Reference: U.S. Geological Survey TRIGA Reactor (GSTR), Docket 50-274, License R-113, Request for Additional Information (RAI) dated June 28, 2016

Subject: Responses to RAI questions

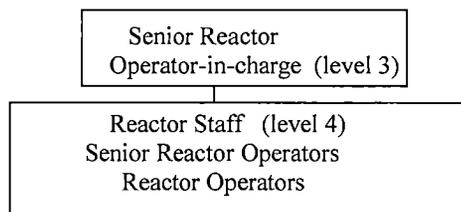
- b. Proposed TS 6.1.1, refers to the reactor administration in (Figure) 1: Administrative Structure. However, the NRC staff finds that figure provided in the proposed TS is only labeled as "1: Administrative Structure," and does not include "Figure" in the title. The NRC staff finds that it would be appropriate to add "Figure" to the title (e.g., "Figure 1: Administrative Structure") to reduce potential confusion when referring to the administrative structure.

Revise proposed TS (Figure) 1: Administrative Structure to add Figure to the title, or justify why no change is needed.

- c. Proposed TS 6.1.1, (Figure) 1: Administrative Structure, provides a position (box) for the Senior Reactor Operator-in-charge. However, the NRC staff finds that the position does not have an indicated authority level in the box.

Revise proposed TS (Figure) 1: Administrative Structure to indicate responsibility level of the Senior Reactor Operator-in-charge, or justify why no change is needed.

Response: We will revise the title to the Administrative Structure figure to include the word "Figure".

Response: We will revise proposed TS Figure 1 to indicate that the Senior Reactor Operator-in-charge is the Level 3 authority and the Reactor Staff is the Level 4 authority, as shown below.

Figure 1: Administrative Structure

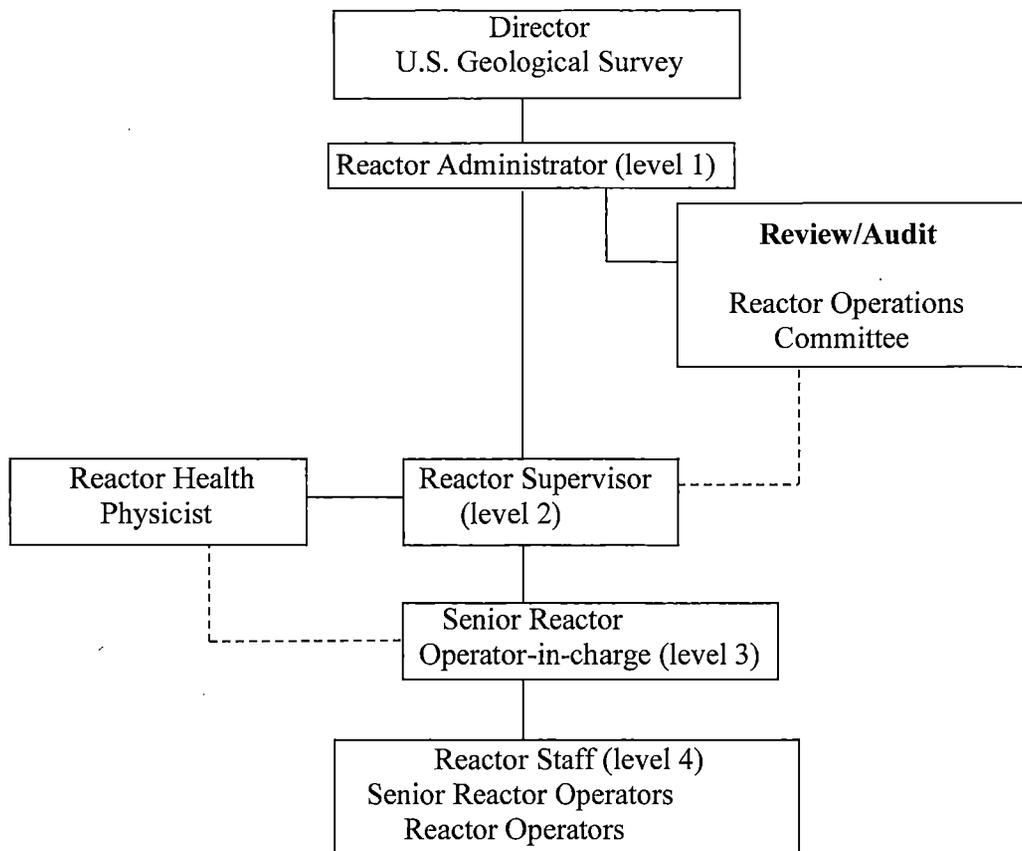
- d. The NRC staff finds that the Radiation Safety Committee Chairperson and Health Physics Staff have been replaced in the proposed TS (Figure) 1: Administrative Structure, with the Reactor Health Physicist.

Provide a basis or justification for the change to the Reactor Health Physicist, or explain why no additional information change is needed.

Revise proposed TS (Figure) 1 to provide reporting and communication lines consistent with the guidance in ANSI/ANS-15.1-2007, or justify why no change is needed.

- f. The proposed TS (Figure) 1: Administrative Structure, Reactor Operations Committee (ROC) illustration box contains information which includes: the ROC, the chairperson, the membership, and the reactor supervisor ex-officio. The NRC staff is not clear if this information constitutes requirements.

Revise the TS (Figure) 1: Administrative Structure, for the ROC illustration box to be consistent with the guidance in ANSI/ANS-15.1-2007.

Response: The change in radiation safety communication is due to the reactor facility no longer possessing licensed materials that are under the purview of the Radiation Safety Committee Chairman or the associated USGS employee. This is a result of the GSTR license amendment number 12, issued

Response: We will revise Figure 1 to show a communication line from the Health Physicist to Level 3 (Senior Reactor Operator-in-charge). The current Figure 1 does show a reporting line to Level 2.

Response: Since we are not being allowed the option of justifying why not change is needed, we will revise Figure 1 to show a Review/Audit box comprised of the Reactor Operations Committee and no other details will be shown (see below).
